Addendum No. 3

**Post Point Sludge Tank Replacement Project
City Project No.: EU194
Bid Number: 3B-2026**

October 15, 2026

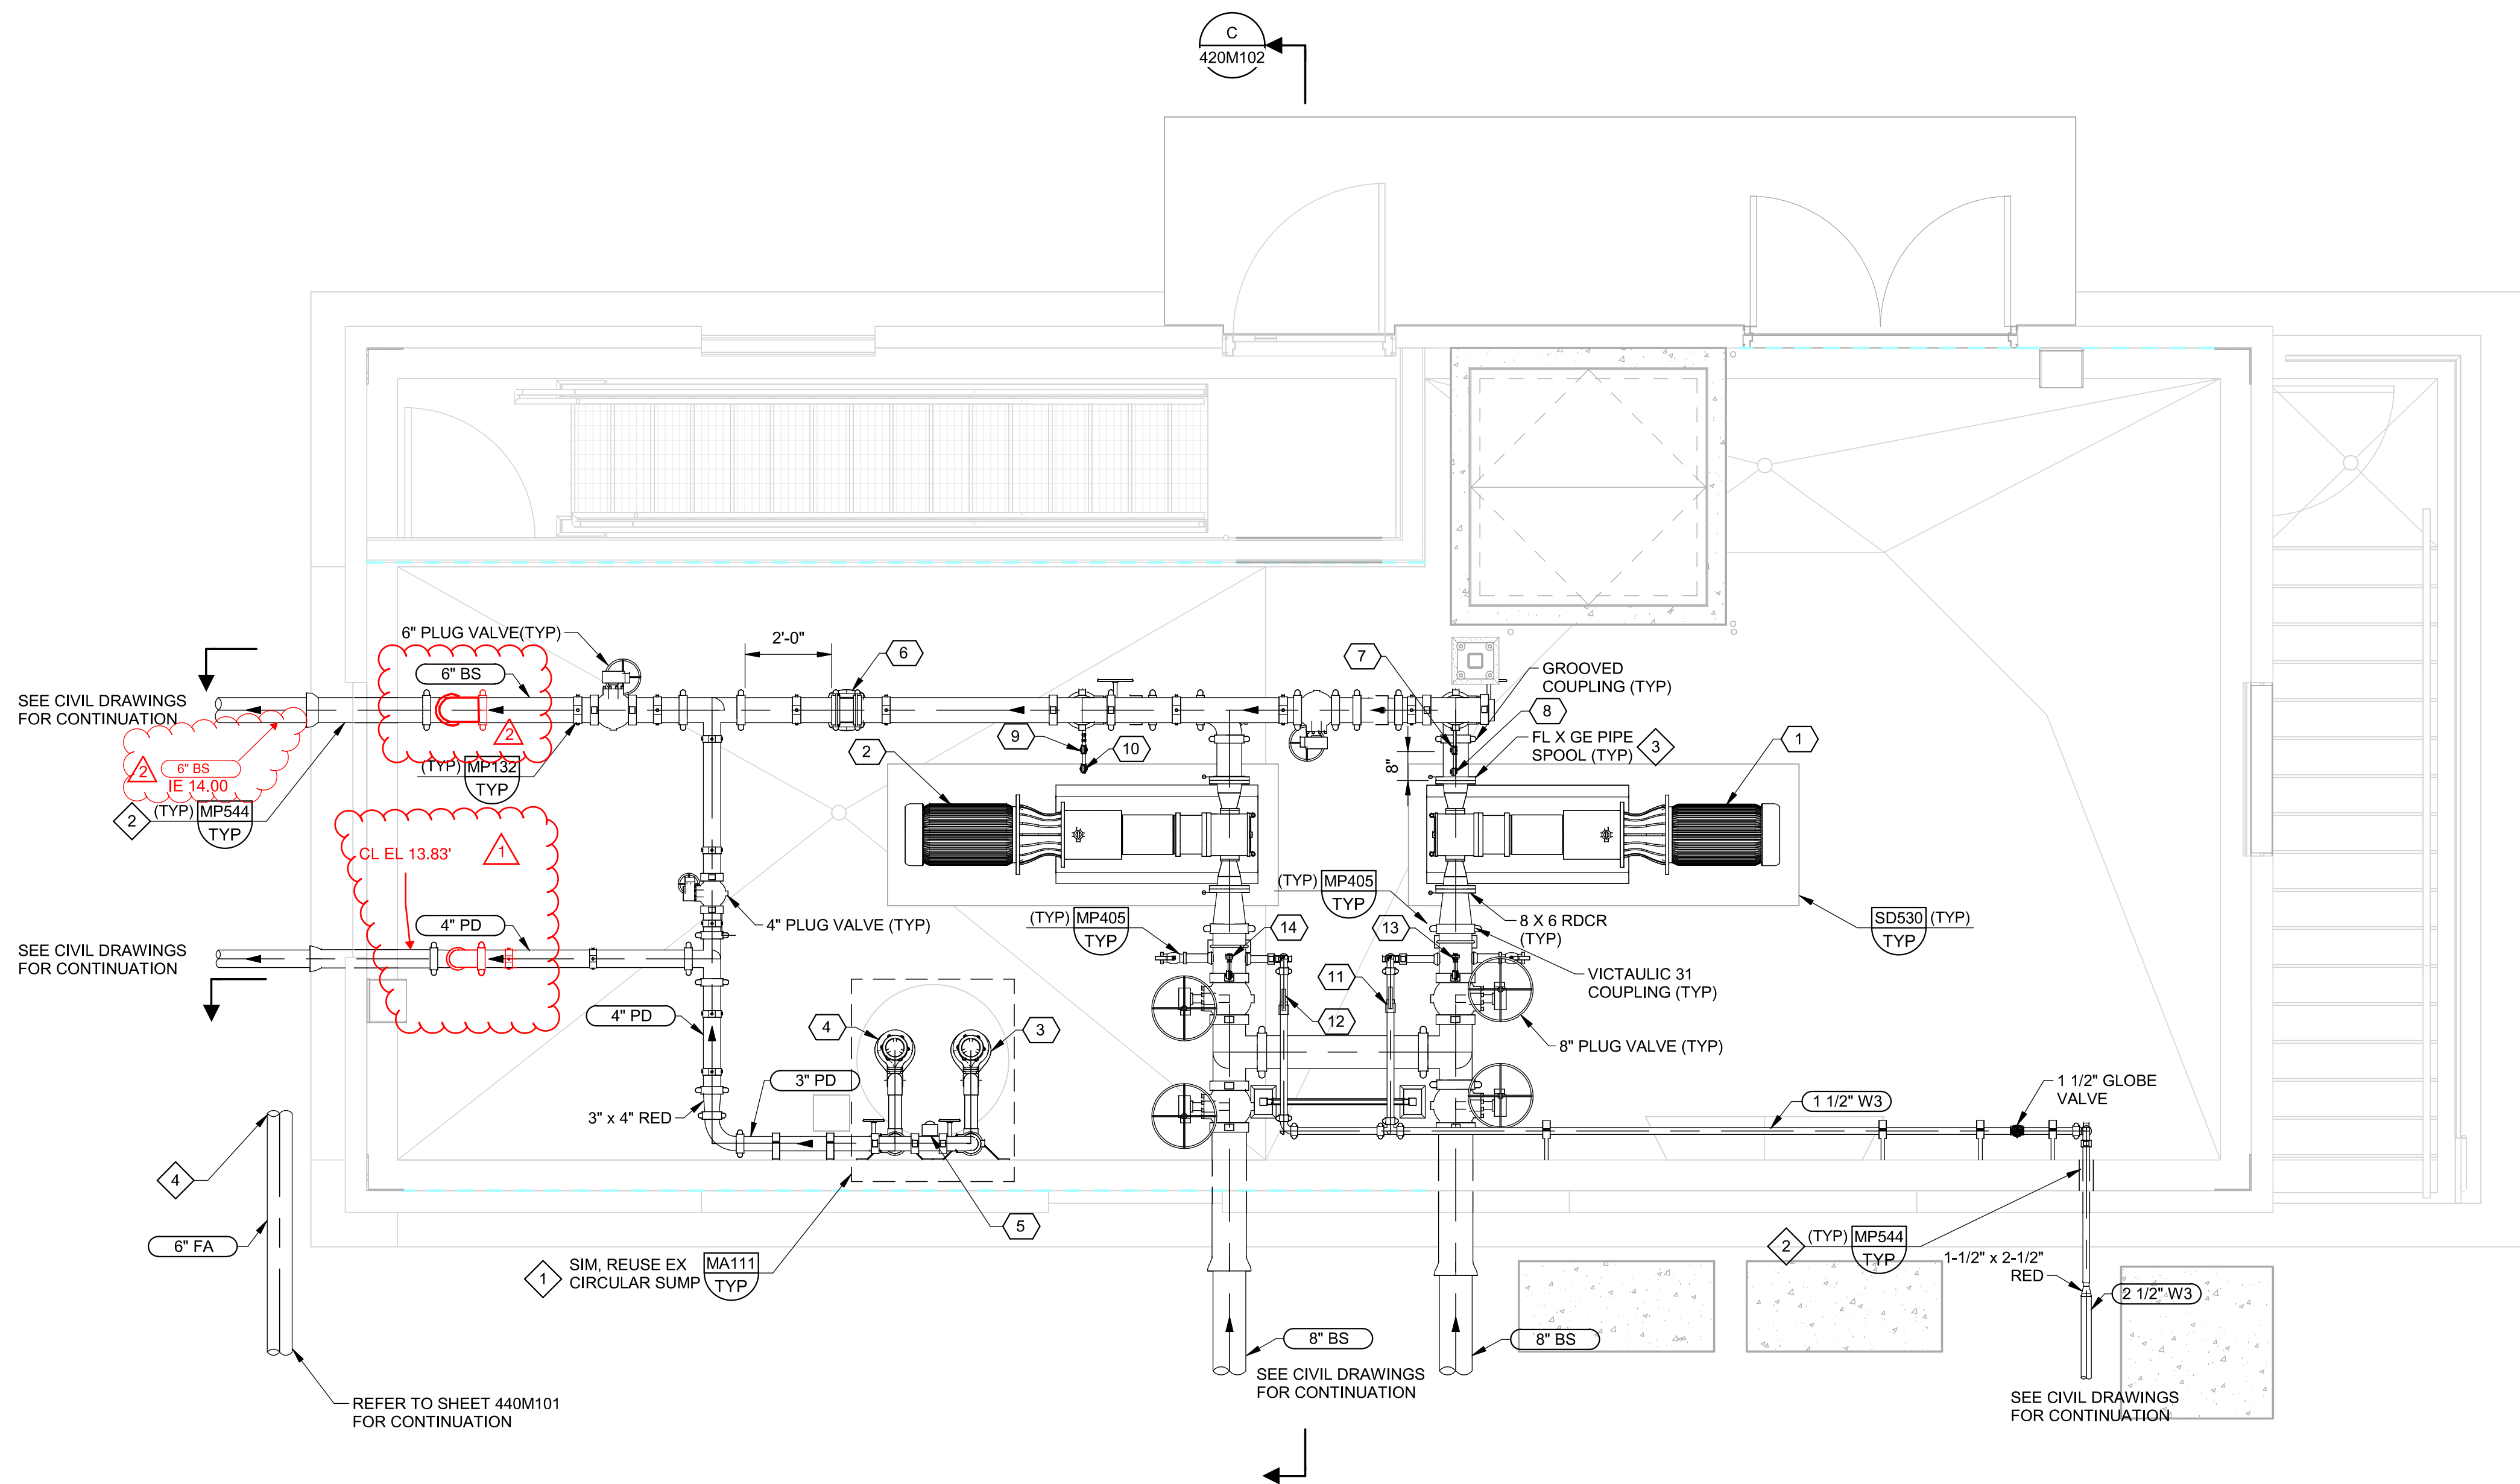
1. Drawing 030C102 – YARD PIPING PLAN
 - a. **DELETE** and **REPLACE** in its entirety. Drawing provided as Attachment A in this Addendum.
2. Drawing 420D101 – SCRUBBER BUILDING DEMOLITION GROUND LEVEL PLANS
 - a. **ADD** the following general notes:
 - i. “11. DEMOLISH LIGHTING FIXTURES AND ASSOCIATED CONDUIT AND WIRING.”
 - ii. “12. SEE 320DE101 FOR ADDITIONAL ELECTRICAL DEMOLITION REQUIREMENTS FOR AREA 420.”
3. Drawing 420D102 – SCRUBBER BUILDING DEMOLITION GROUND LEVEL PLANS

Response: Both the 6" PD and 4" PD invert elevations were issued with Addendum 2 in Attachment A. The invert elevations for the remaining pipes are included in Attachment A with this Addendum. The finished grade can be found in 020C107.

Response: See Addendum 2 for the answer to this question, and the updated version of Drawing 030C102 included in Attachment A to this addendum.
